Bond Reimbursement & Grant Review Committee

Report to the Legislature

Criteria for Cost-Effective School Construction

December 2017

Figure 1: Alaska Climate Zone Map

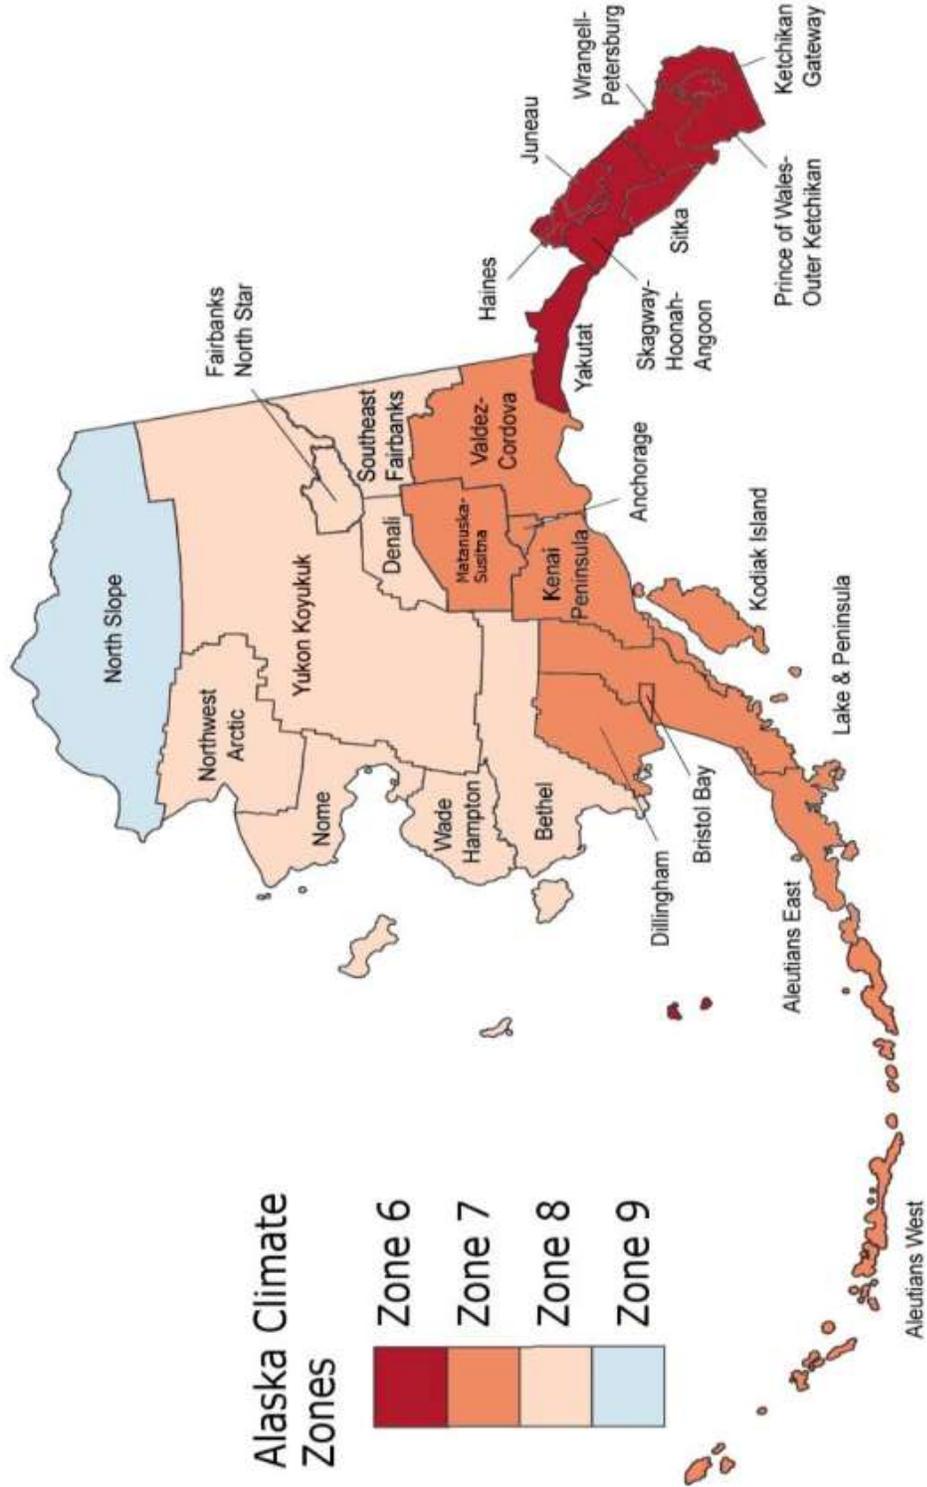
PUBLIC COMMENT RECEIVED	BR&GR RESPONSE
<b>Recommendation #1 (Adopt Alaska Building Energy Efficiency Standard Climate Zones)</b>	
<p>Clarify if adoption of four BEES climate zones would be substituted for the two climatic regions noted in ASHRAE 90.1 or would ASHRAE 90.1 be replaced as the standard with BEES exclusively. (<i>ref. KPhillips, 11-15-17</i>)</p>	<p>The intent of adopting the BEES climate zones is to more specifically represent the different climate zones as they influence facility design priorities when comparing ratios only. The current requirement to meet ASHRAE 90.1 would not change.</p>
<b>Recommendation #2 (Implement Design Ratio Openings Area to Exterior Wall Area)</b>	
<p><u>I would be in favor of a lower O:EW ratio</u> for the following:</p> <ol style="list-style-type: none"> <li>Natural light is extremely important but it doesn't take an entire exterior wall of windows to give adequate light. I feel less but strategically placed windows would offer a quality interior natural light effect.</li> <li>In windy climates like [Bering Strait School District] windows are one of our larger maintenance expenses. We are continually fixing mechanisms and experience full failures as early as 15 years. The glass vendors love us! Our most troubled areas are classrooms with the entire exterior wall length being window. The lack of framing structure between each window creates a weak point, that moves in the wind, which loosens casings and loosens window edges allowing argon to escape. We see this in quite a few of our schools. With a lower O:EW ratio designers may look at getting away from continuous long banks of windows.</li> <li>With LED lighting being used the cost of offsetting natural lighting with electric lighting isn't as big of a deal. Also LED replicates the spectrums of natural lighting much better.</li> <li>And of course the difference between r-5 and r-30 but as time factors in windows are not their original r-value and leak.</li> <li>Less windows, less problems. (<i>GEckenweiler 11/9/2017</i>)</li> </ol>	<p>Thank you for the support. Natural light and views to the exterior will remain important factors for owners and designers to consider within the energy-driven limitations of the O:EW ratio.</p> <p>Thank you for the input. However, limiting glazing with the O:EW design ratio would not necessarily make up for missing framing. Best practice related to that issue should be incorporated in the proposed Model Alaskan School criteria or in the district's design standards.</p> <p>Thank you for the input.</p> <p>Thank you for the input.</p> <p>Thank you for the input.</p>

Comment: 1. – Clarify if adoption of four BEES climate zones would be substituted for the two climatic regions noted in ASHRAE 90.1 or would ASHRAE 90.1 be replaced as the standard with BEES exclusively.
